DOCUMENT CHANGE REQUEST

DCR number 382	Changes required for: General	Originator: S Jeffery
Date: 2007/10/16	Date sent: 2007/10/16	Organisation: ESA/ESTEC
Status: IMPLEMENTED

Title:	Transistors Low Power NPN, based on types 2N3498 thru 2N3501		
Number:	5201/013	Issue:	1

ESCC Detail Specification No. 5201/013

1.6.1 Metal Can Package (TO-5) - 3 lead

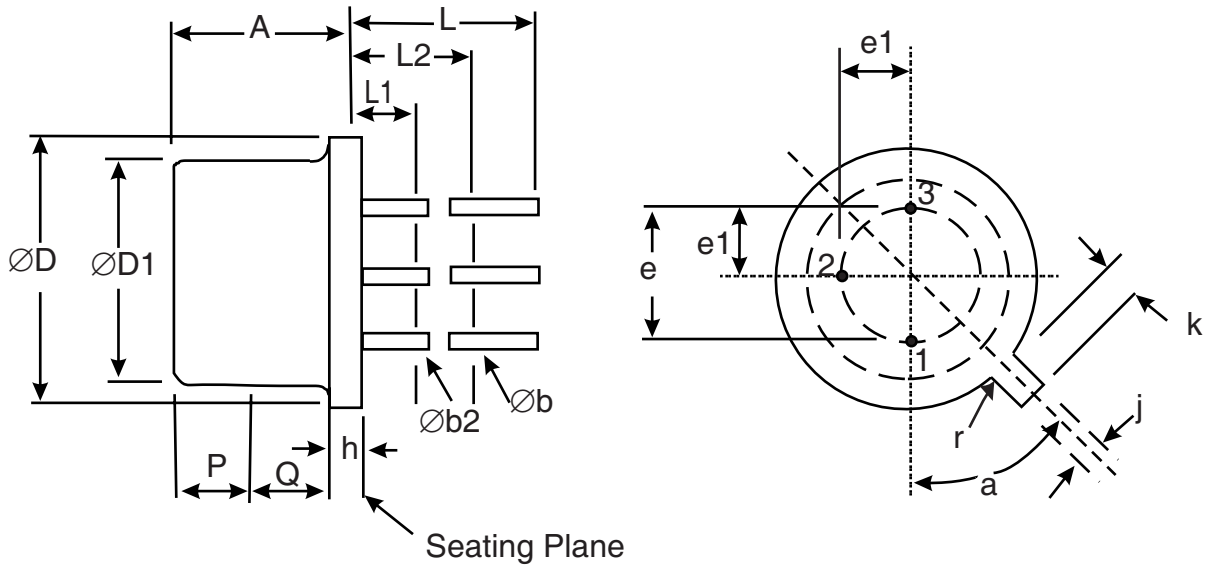
8. Figure 2 re-named "Physical Dimensions and Terminal Identification"; Figures 2(a) and 2(b) amended (standardisation of the TO-5 and TO-39 packages).

6. Standardisation of the TO-5 and TO-39 packages in all applicable ESCC Detail Specifications.

VOLTAGE WAVEFORMS

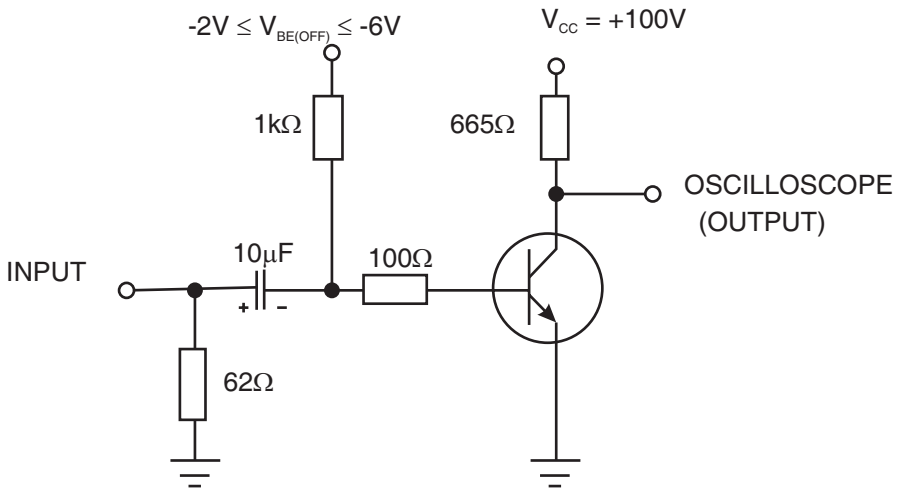
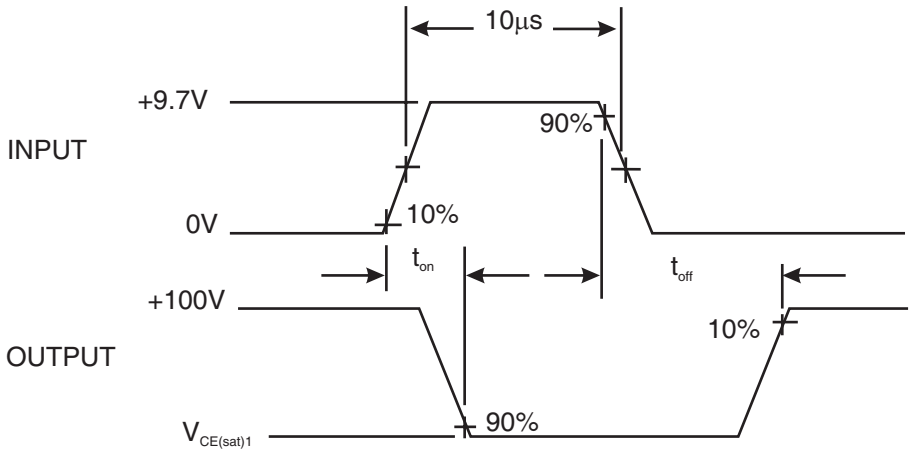
22. Figure 4 amended (and Voltage Waveforms added) and moved to be a note (Note 3) to Room Temperature Electrical Measurements.

1. Pulsed measurement: Pulse Width ≤ 300µs, Duty Cycle ≤ 2%.
2. For AC characteristics read and record measurements shall be performed on a sample of 32 components with 0 failures allowed. Alternatively a 100% inspection may be performed.
3. t_{on} and t_{off} shall be measured using the following test circuit. The input waveforms for t_{on} and t_{off} shall be supplied by a pulse generator with the following characteristics: Z_{OUT} =50Ω, $t_r = t_f \leq$ 20ns, Pulse Width ≥ 10µs, Duty Cycle ≤ 2%. The output waveforms shall be monitored on an oscilloscope
